**PLANNING COMMISSION MEETING**  
**Tuesday March 12, 2024**  
**7 PM**

- a. Public hearing to consider a development application of Medart Inc. for an administrative subdivision, easement vacation, and PUD amendment/site and building plan for the development of a 105,157 sq. ft. industrial building on Lots 1 and 2, Block 1, AVA Second Addition. (page 5-23, Exhibits A-J)
- b. Public hearing to consider a sign code text amendment allowing signs within City playfields within Central Park - Tabled from February 13, 2024, Planning Commission meeting. (pages 24-27, Exhibit A)

TO: Adam Nafstad  
FROM: Alan Brixius  
DATE: February 27, 2024  
RE: Medart Industrial  
FILE NO: 163.06 24.01

**LANDSCAPE PLAN**  
**L2.1**

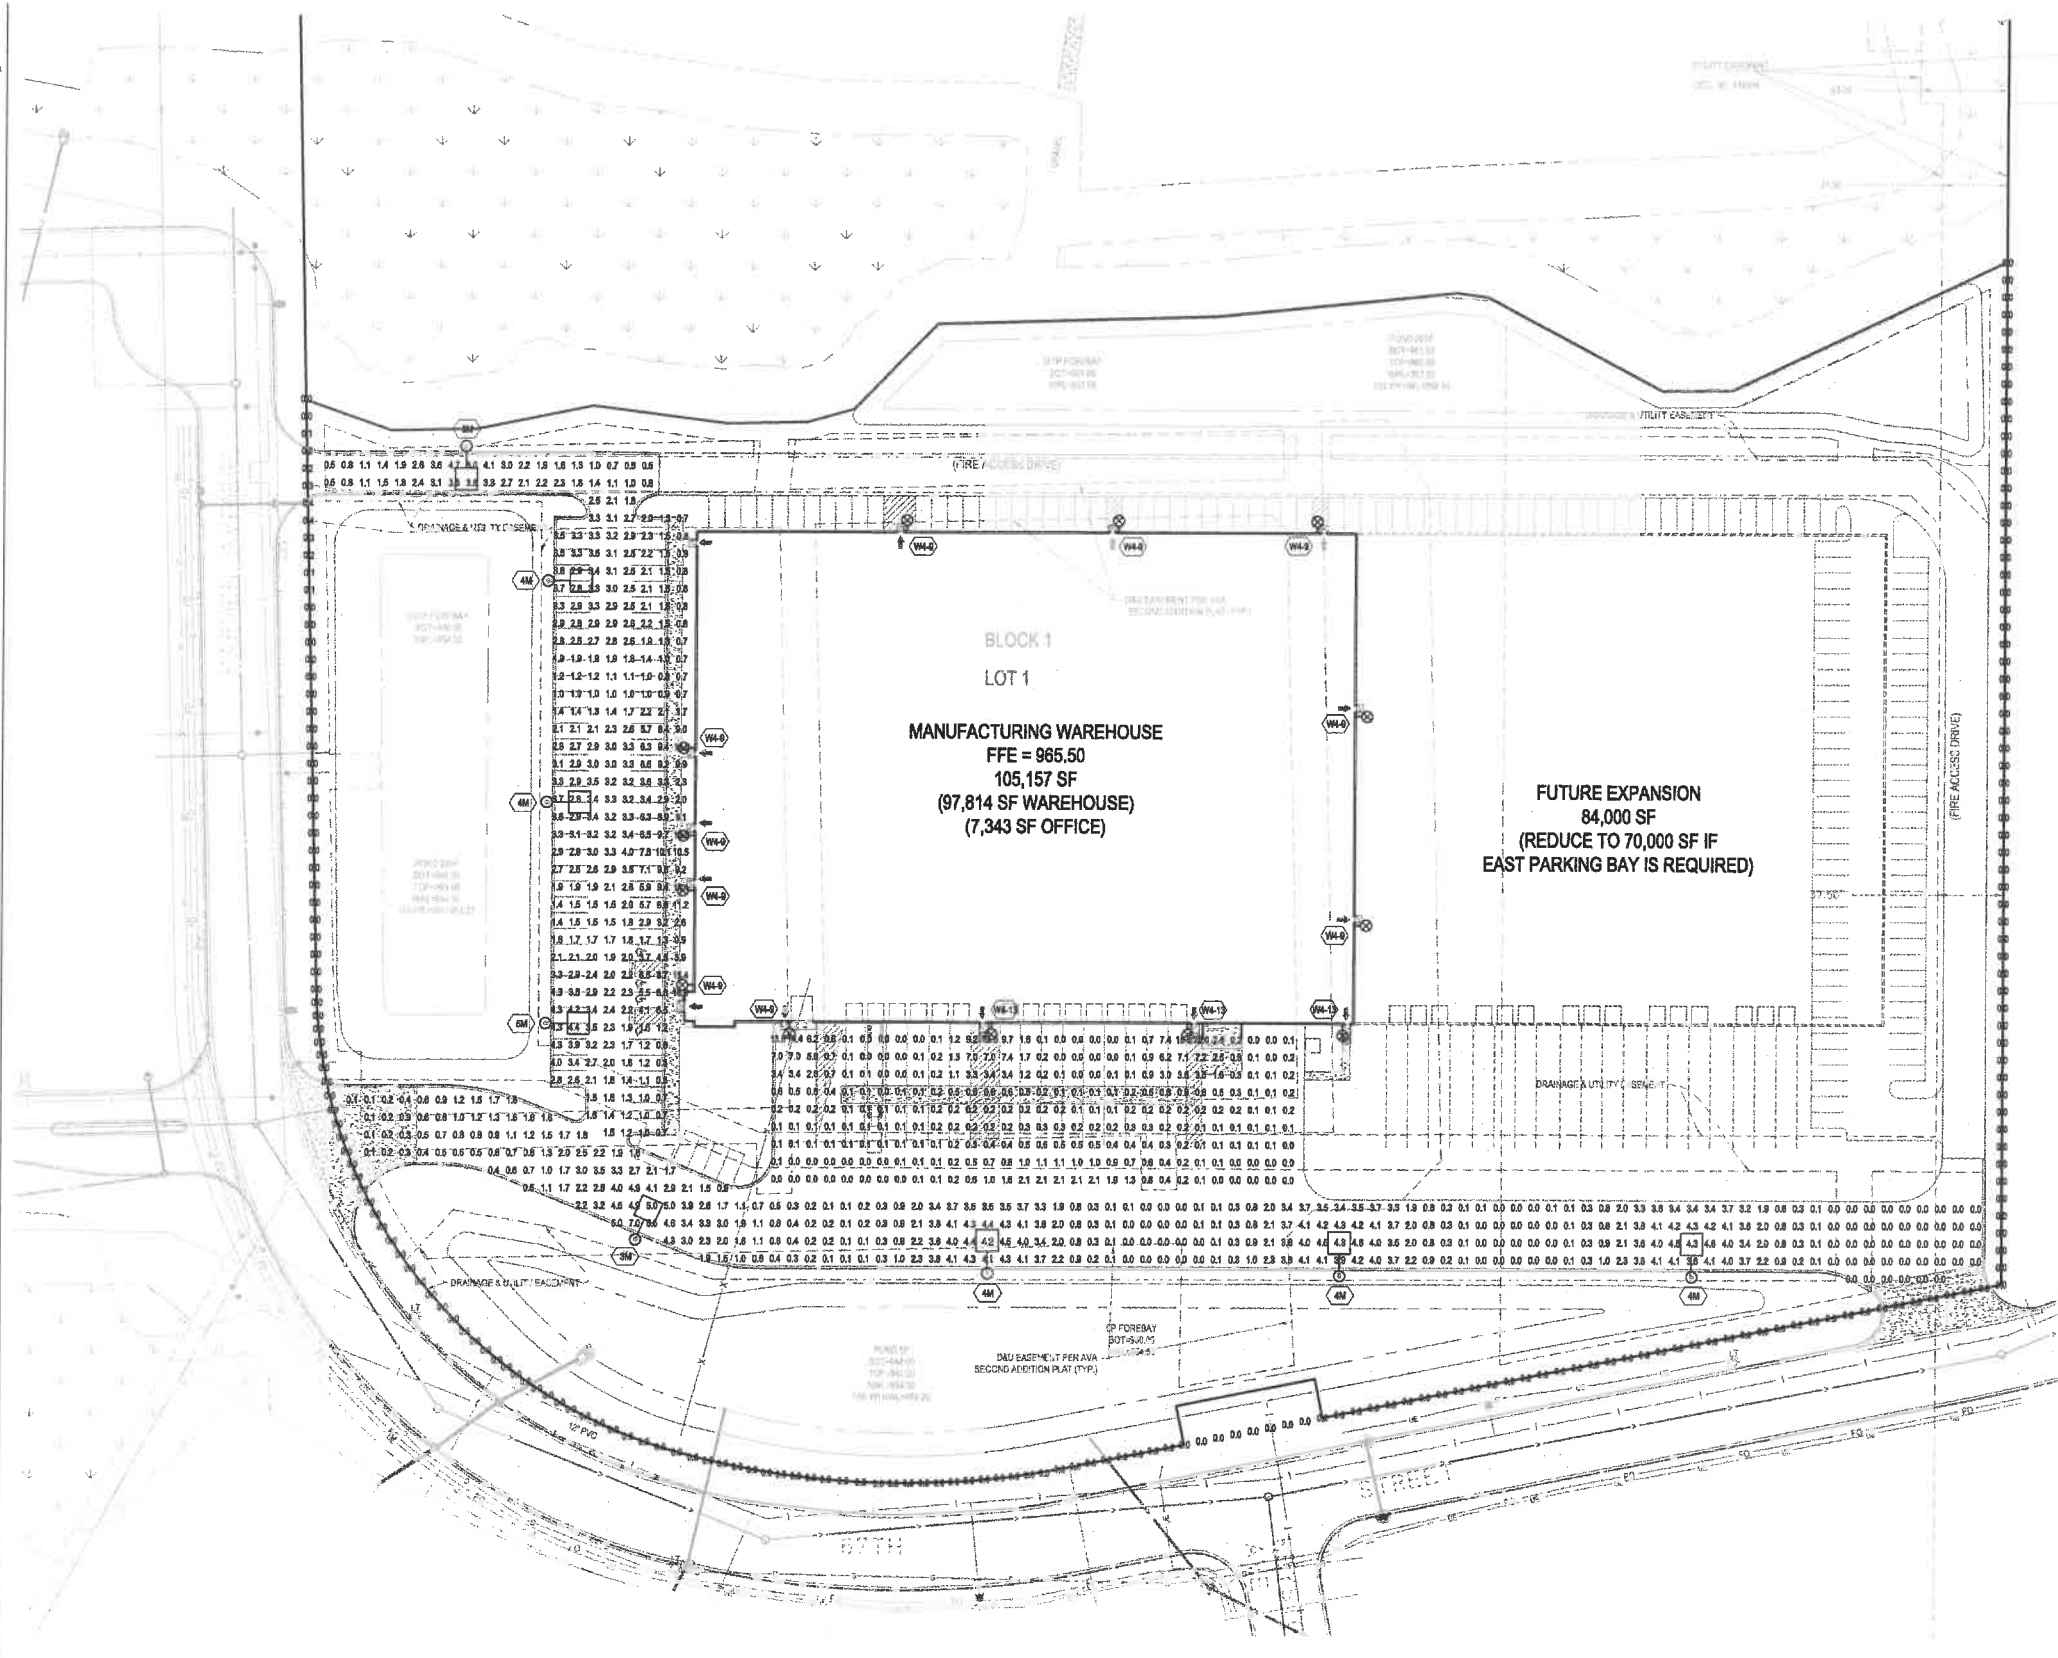
1. The site plan does a good job reestablishing ground cover over the areas disturbed by grading with sod and seed mixes that are appropriate for their areas of use.
2. The southern loading area is required to be screened from 67<sup>th</sup> Street. The landscape plan proposes single row plantings along the south curb line of the loading area. The trees consist of 8 foot tall coniferous trees. The base of the loading berths at the building is at a 961.5 elevation. The proposed trees are being planted at a 959 elevation. In this arrangement, the trees will not provide

- b. The landscape screen shall be extended for the full length of the initial construction and the proposed future addition, to allow the plantings to grow and mature together, becoming a more effective screen over time.

- c. A landscape screen or screen wall shall be provided within the green space along the west end of the loading berths.
3. The zoning code requires screening at that periphery of the parking lot from the public street. The landscape plan must provide screening either landscaping or fence along the western edge of the west parking lot. Said screen shall be of a height to screen headlights directed toward the public street.

4. The plantings along the west side of the building meet the City requirements of the zoning code.
  5. The site and landscape plan must illustrate landings and clear paths from the doors on the north and east sides of the building to a drive aisle. These landings and clear paths shall be kept clear of obstructions and snow year-round.

8. The landscape plan shall be revised to include the following.
  - The landscape screening shall consist of a double stagger row of coniferous trees. Trees shall be a minimum of 8 feet in height. The spacing of trees in the same row shall be no greater than ten feet on center.

- The landscape screen shall be extended for the full length of the initial construction and the proposed future addition, to allow the plantings to grow and mature together, becoming a more effective screen over time.

- A landscape screen or screen wall shall be provided within the green space along the west end of the loading berths.
  - The landscape plan must provide screening either landscaping or fence along the western edge of the west parking lot. Said screen shall be of a height to screen headlights directed toward the public street.
